REVIEW of RI/FS WORK on the ACME SOLVENTS SITE

REVIEW OF THE RI/FS REPORT
ON THE ACME SOLVENTS SITE

FOR THE
ACME TECHNICAL COMMITTEE

PREPARED BY
EUGENE A. HICKOK AND ASSOCIATES
WAYZATA, MINNESOTA 55391

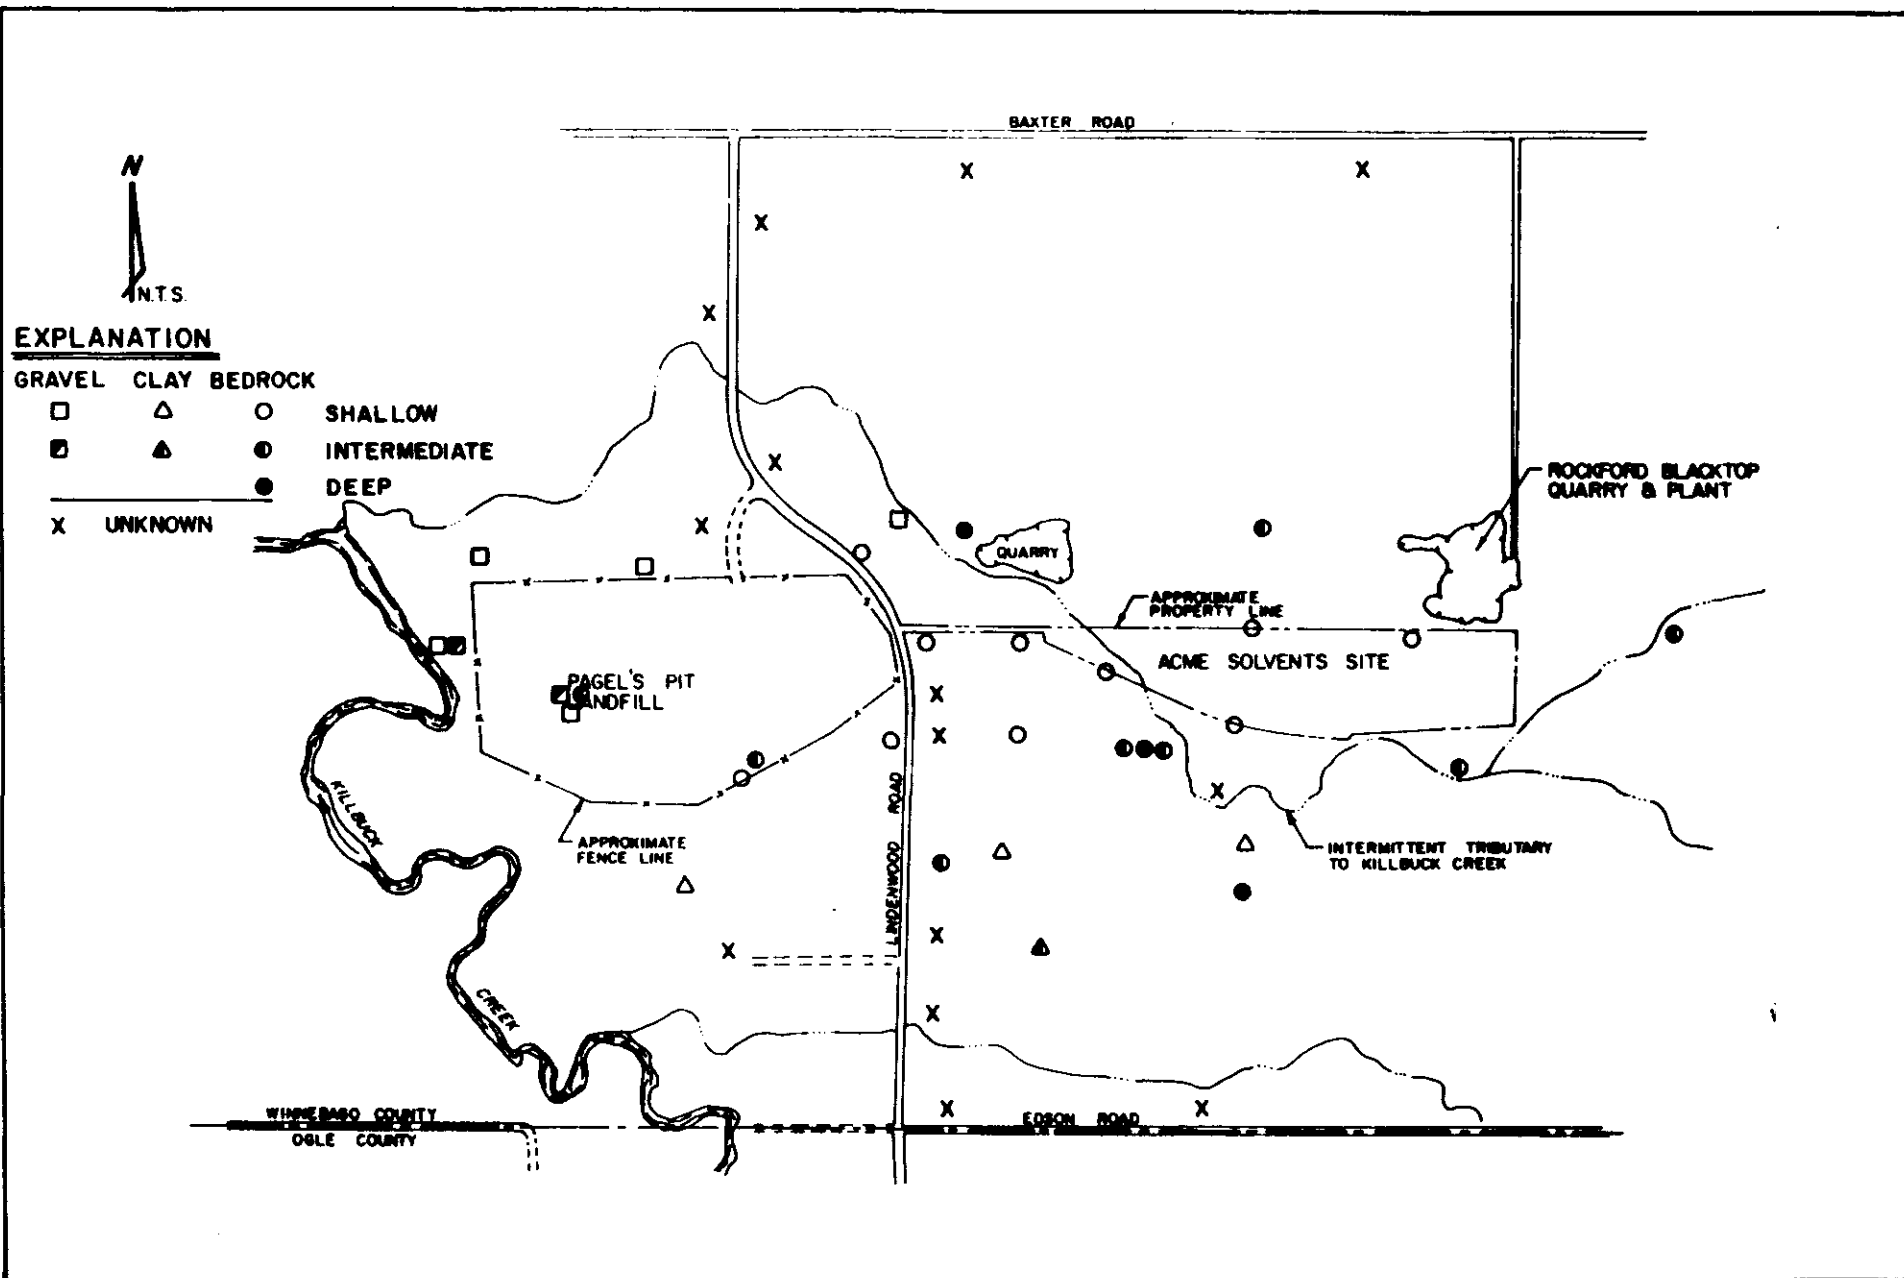
The three deep wells lie virtually on a straight line trending northwest-southwest (see Figure 2.4). (Again, the "deep" wells penetrate only the upper half of the shallow aquifer.) This linear configuration prevents a complete determination of the horizontal groundwater flow gradient in the stratum of the deep wells.

The wells in the Pagel's Pit area of intermediate depth also lie very close to a straight line (trending from west-northwest to east-southeast; see again Figure 2.4).

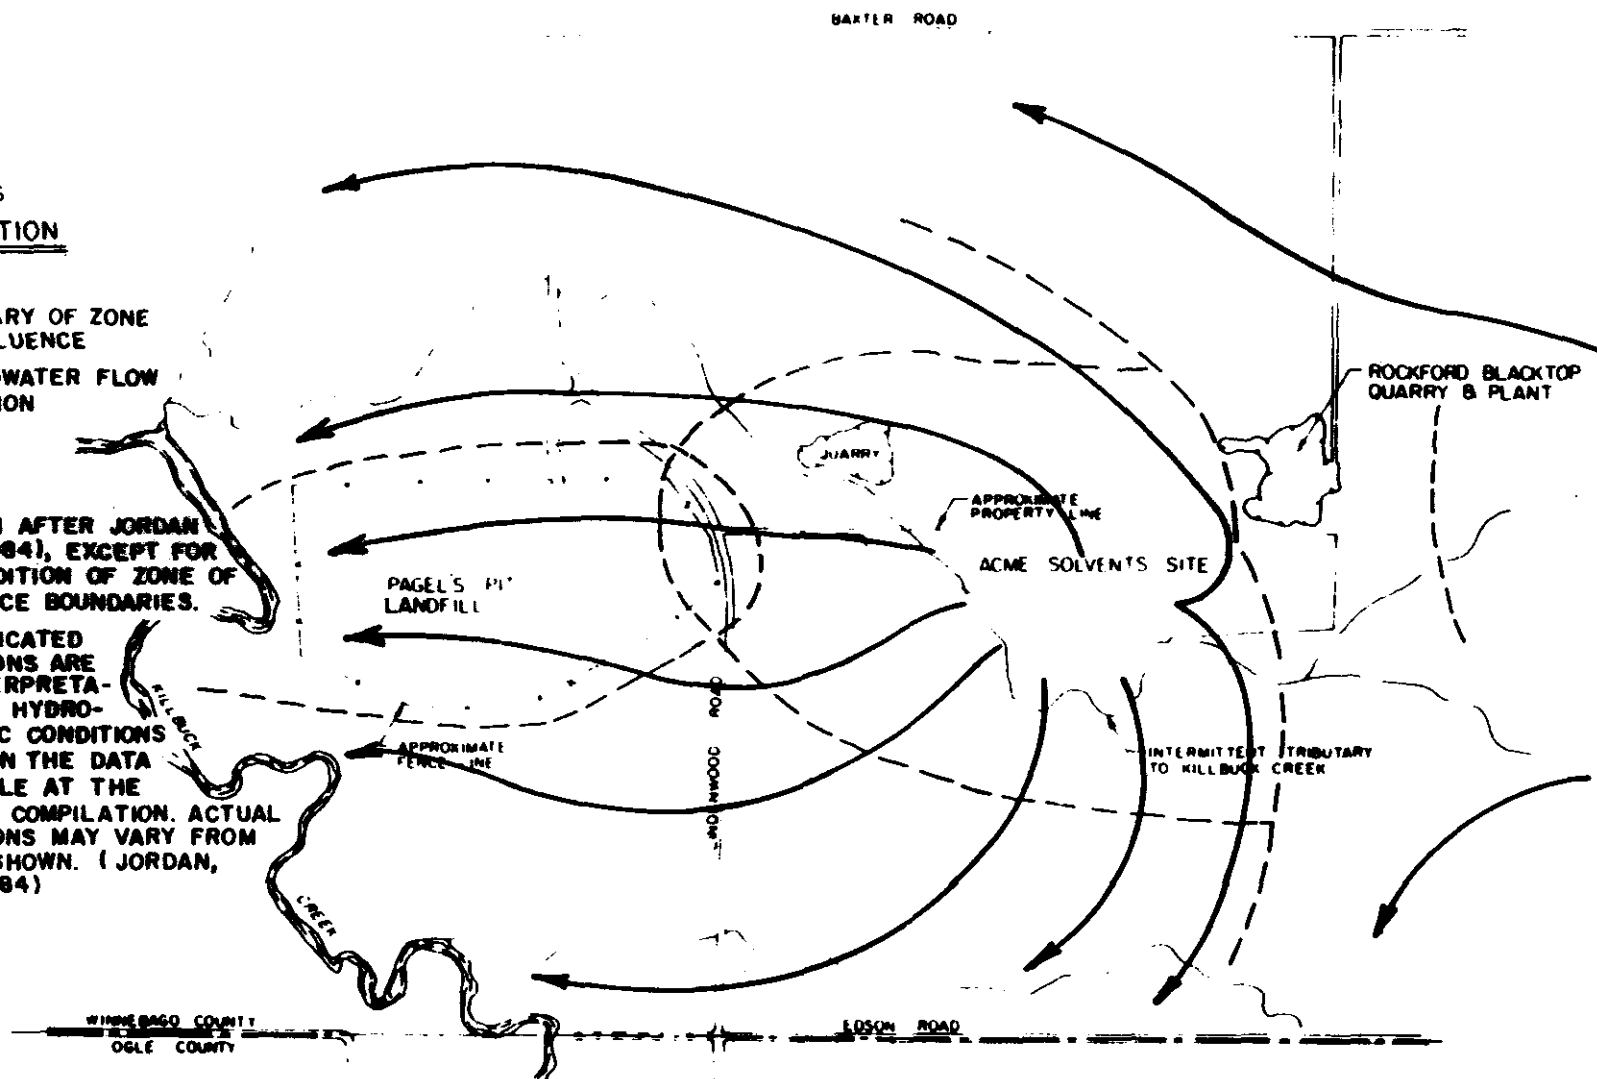
after Figure 21 in Jordan (Sept. 1984). As discussed in section 4.1, the flow pattern shown here appears to be a valid representation for the shallow wells. While it is not accurate for the strata corresponding to intermediate and deep wells, it is nevertheless adopted here as an approximate basis for horizontally sorting all wells having water quality data and known depth.

Accordingly, "zones of influence" consistent with the flow pattern are shown in Figure 2.5. The Acme site zone extends downgradient (i.e., north, west and south) from the site approximately 800 feet; this is approximately the maximum distance that contaminated groundwater could have traveled from the site since operations began there. The westerly extent intersects the Pagel's Pit zone of influence, thereby defining a boundary zone between the two sites. The easterly boundary of the Acme zone corresponds to the easterly limit of concentrated waste deposits on the site, as mapped by Jordan (Sept. 1984, Figure 24).

Note that groundwater flow lines at the Rockford Blacktop quarry and plant run more nearly north-south than east-west. It appears likely that flow lines diverge from this location, since bedrock is extensively exposed there, and there is a large area of negligible recharge located a short distance to the south. In other words, Rockford Blacktop's zone of influence probably extends both southward and northward from the quarry and plant.

E. C. JORDAN'S INTERPRETATION OF
VERTICAL GROUNDWATER FLOW

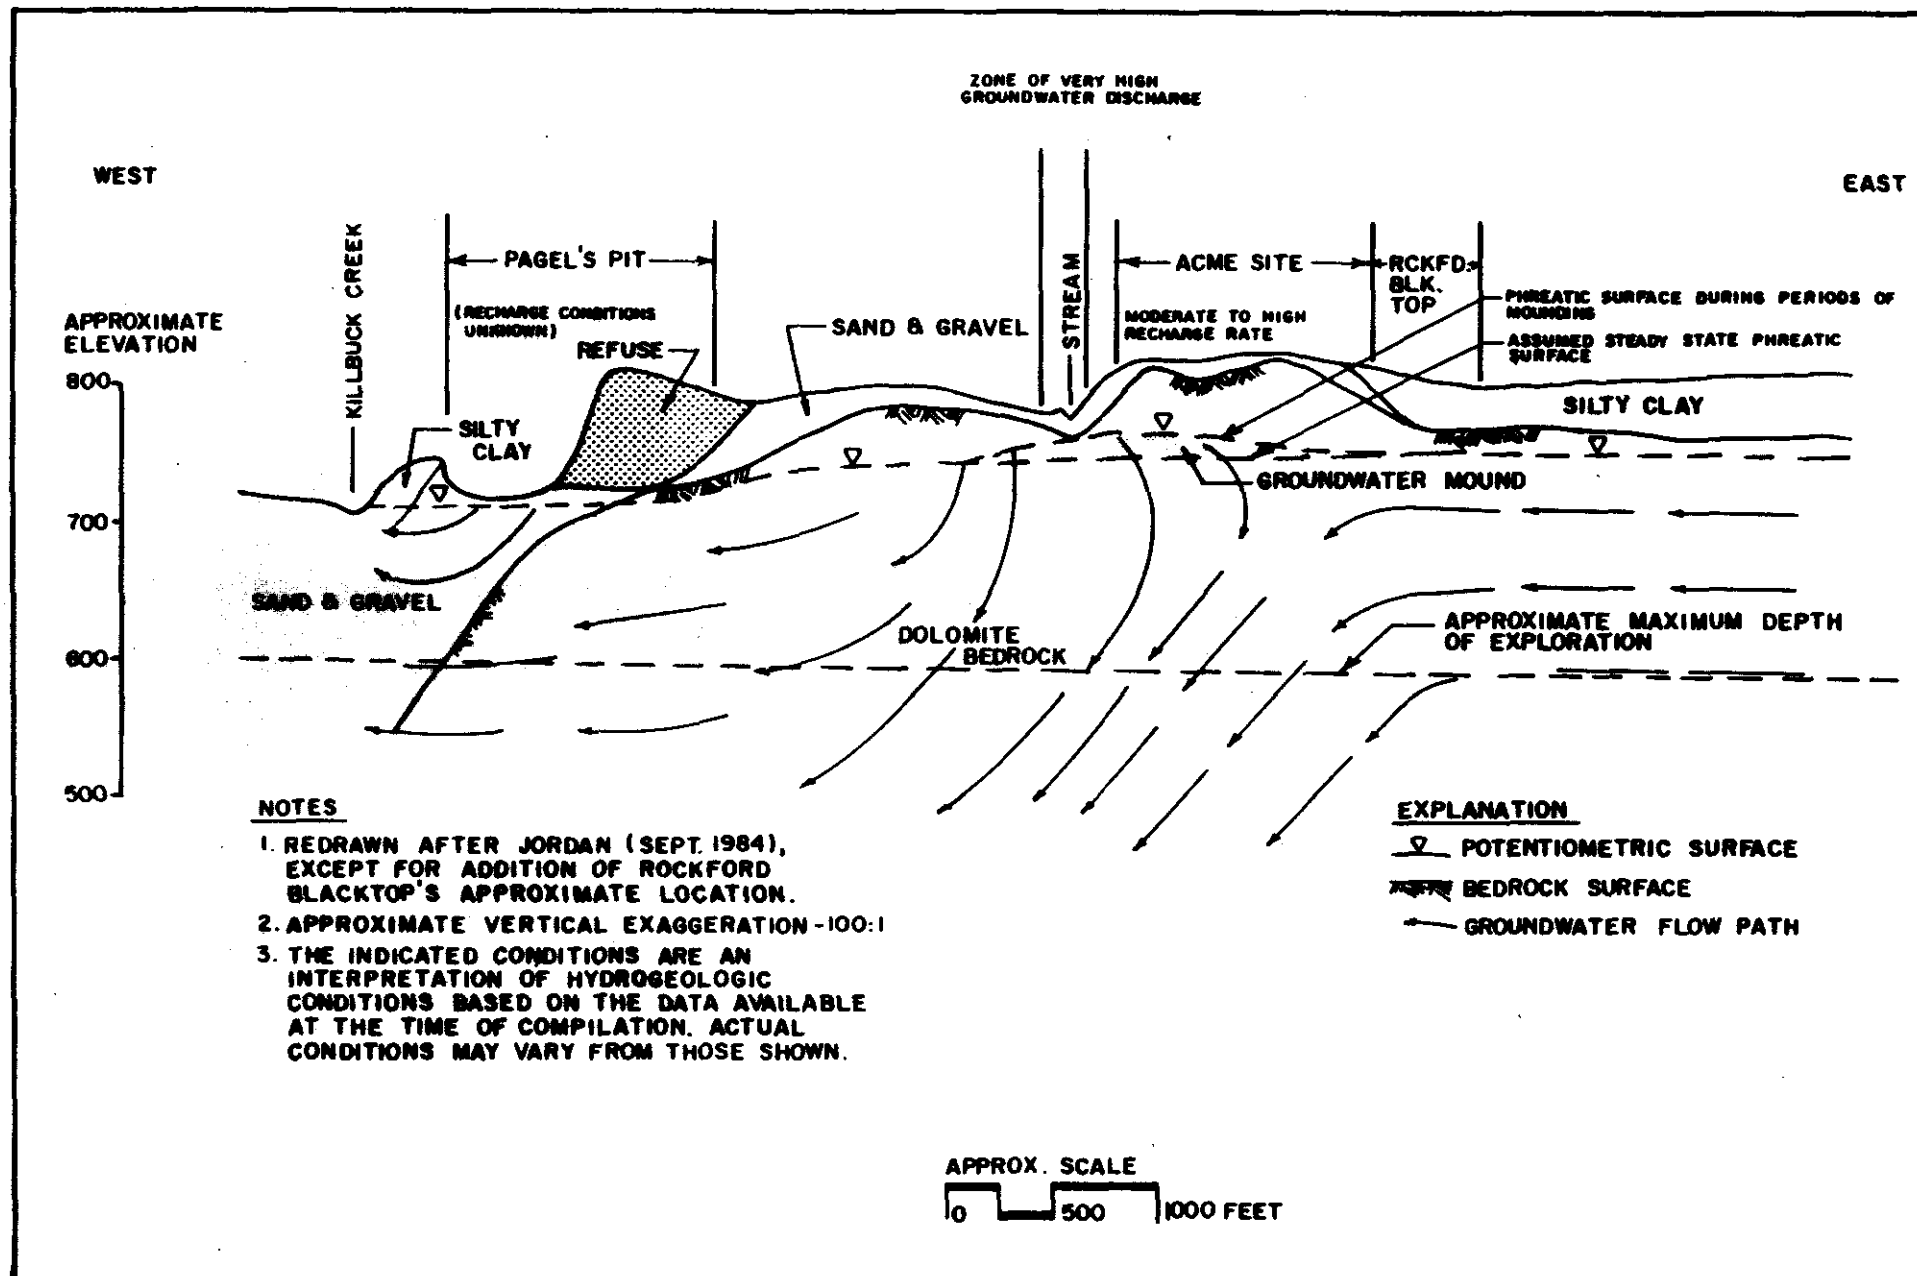
that contaminants originating from upgradient of the Acme site will move downward below the site to greater depths in the aquifer. This gives a possible explanation for the deep contamination observed in the Acme site zone, in spite of the absence of volatile organics there at intermediate depths.

The May conditions are generally consistent with E. C. Jordan's interpretation of vertical groundwater flow, as depicted in Figure 2.7, for the Acme site vicinity. However, near Pagel's Pit and Killbuck Creek, the interpretation in Figure 2.7 corresponds to March-April conditions, rather than those in May.

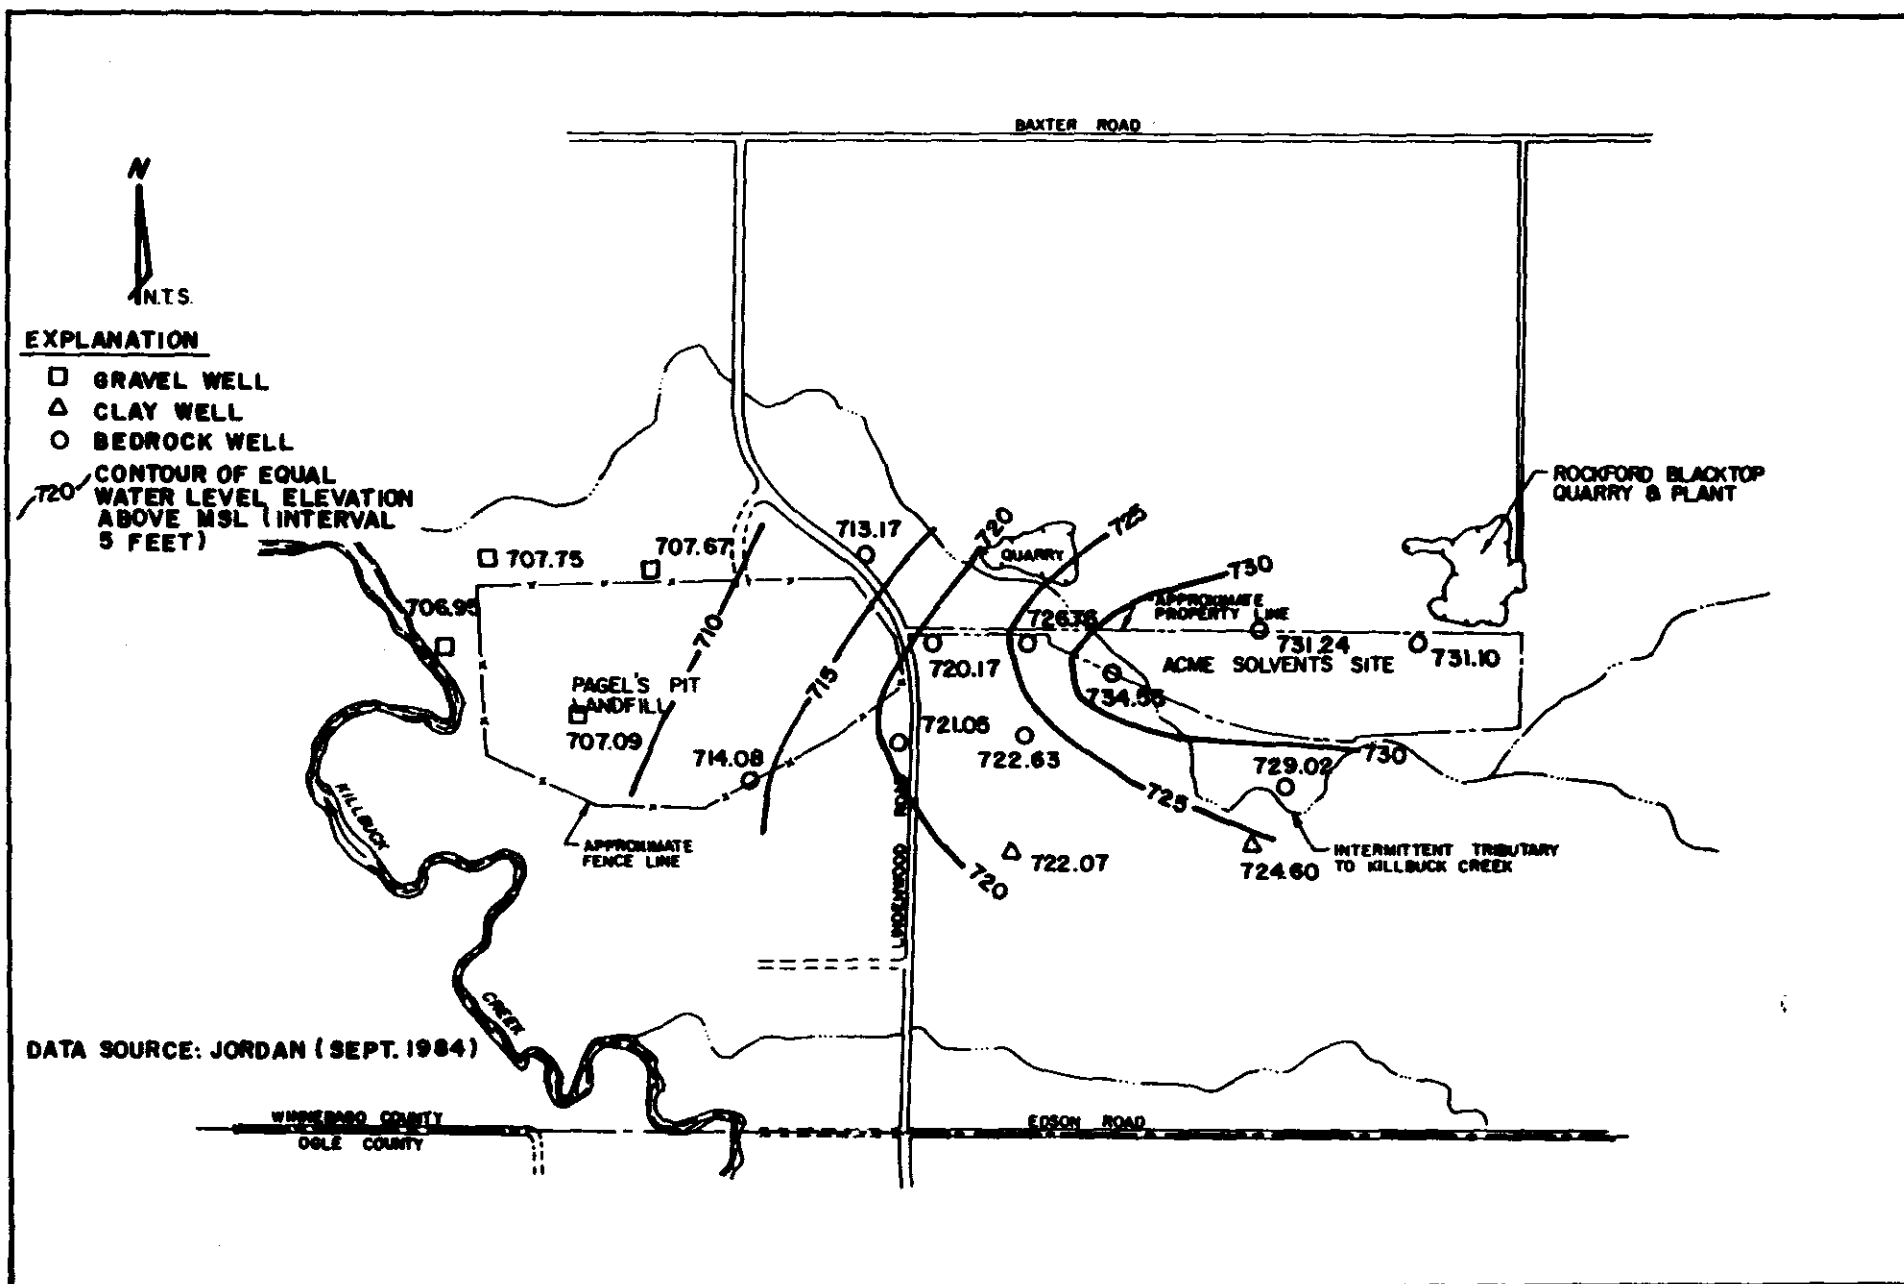
For the shallow wells (Figure 2.18), the horizontal pattern of head indicates generally west-northwesterly flow, but with radial components emanating from the Acme site vicinity. The pattern was similar from early March through early May, with minor variations.

The implied flow pattern is in good agreement with E. C. Jordan's interpretation (see again Figure 2.5). However, Figure 2.18 depicts conditions only in the upper one-tenth of the shallow aquifer. Jordan's interpretation, on the other hand, seems implicitly to describe the entire shallow aquifer. The flow pattern is actually quite different at greater depths.

The contours of hydraulic head in Figure 2.18 represent the elevation of the water table. For wells at greater depths, however, water level (hydraulic head) measurements can differ from water table elevations; and such differences occur in the area of concern here.
